Summary of the discussions concerning the shroud

Bernhard Schwingenheuer, MPI-K Heidelberg

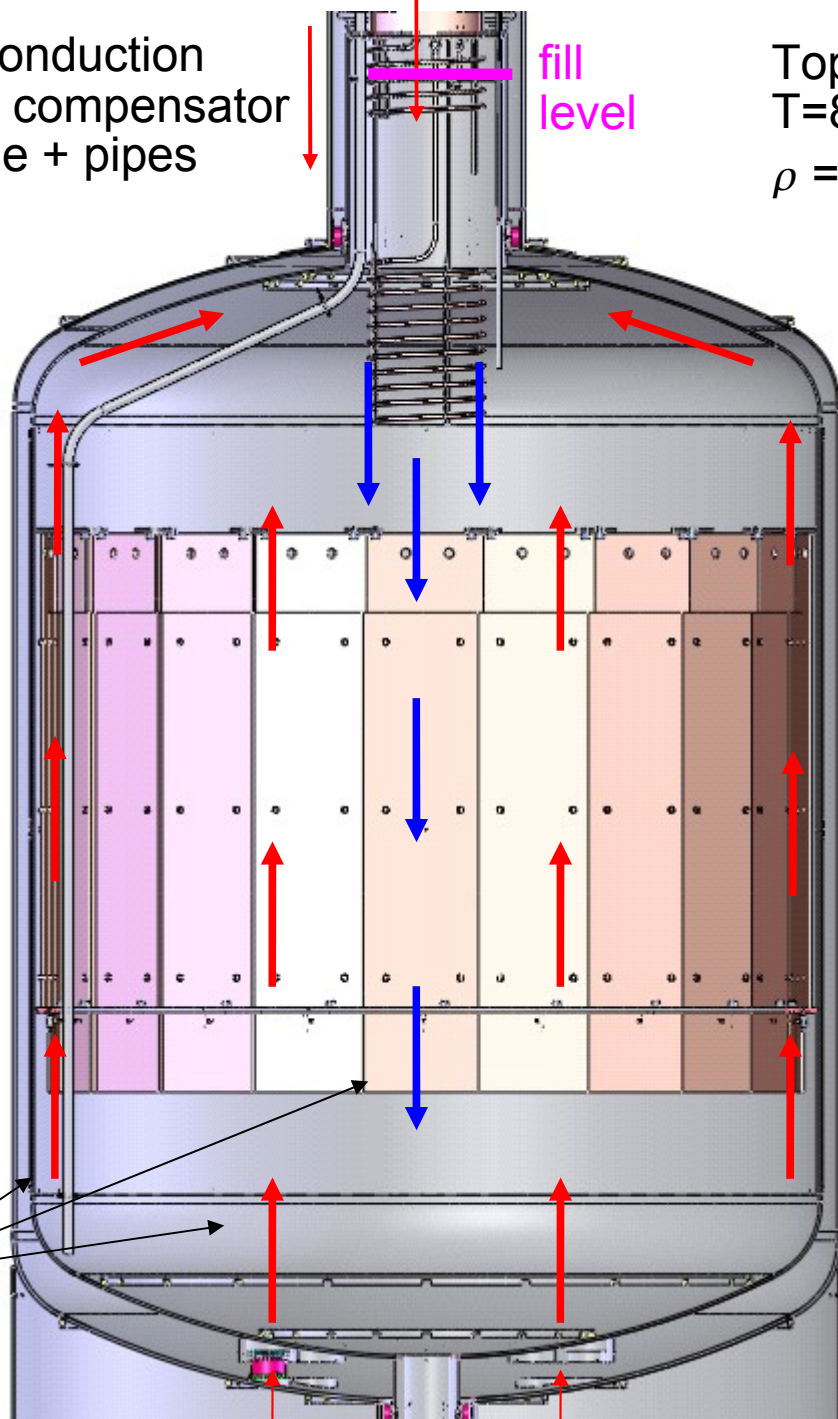
- convection will transport Rn from source=wall to crystals
- uniform Rn concentration too optimistic (circulation time $\sim T_{1/2}$)

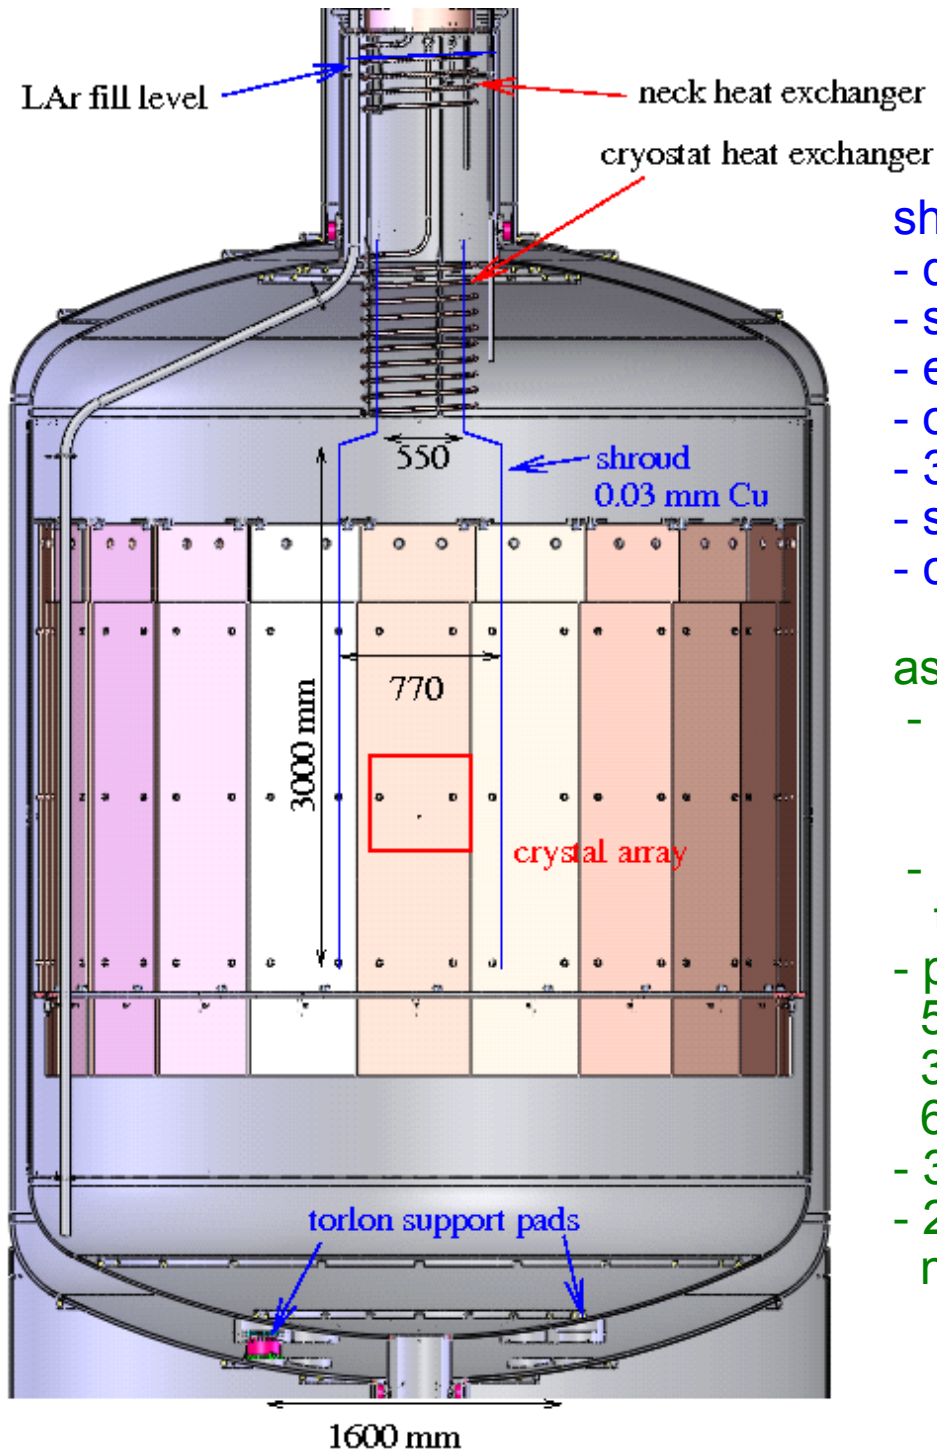
- a simple design comes more and more complicated to cure problems introduced by each step (steel cryostat → add copper shield → add shroud to reduce Rn bkg)
Worry: additional unpredictable complications

- additional material in vicinity of detectors, question of radiopurity
reply: Rn emanation ok, unfortunately even ICPMS is not sensitive enough for bulk activity, copper is OFHC copper from the standard supplier (Norddeutsche Affinerie)

- additional mounting steps & further contaminations of the vessel during mounting
reply: test mounting in HD, no large addition risk of further contaminations during mounting

- unknown convection behavior with the shroud
 - are all heat inputs known?
reply: except for thermal radiation input from top, I am confident
 - temperature gradient inside shroud: cold LAr on top and warm at bottom → mixing

reply: only if LAr in neck has lower temperature → adjust heat exchanger cooling power
(3 temperature sensors in neck, 4 in upper part of cryostat)
 - LAr from cryostat enters shroud

reply: proposal to close the shroud at the bottom to avoid (large) flows of LAr through shroud
- movement of shroud inside LAr → contact with detectors
reply: no known lateral force except earth quake, entire shroud has “large” shear stiffness, LAr dampens movements, no LAr movements since cryostat completely filled

reply: even without the copper shield we need a shroud unless Rn sticks to the walls
(Rn emanation was not discussed for a copper cryostat in GERDA proposal)

reply: only heat input inside shroud from electronics of ~ 0.05 W / channel
→ small or no gradient and only above the Ge array
 - LAr from neck enters shroud
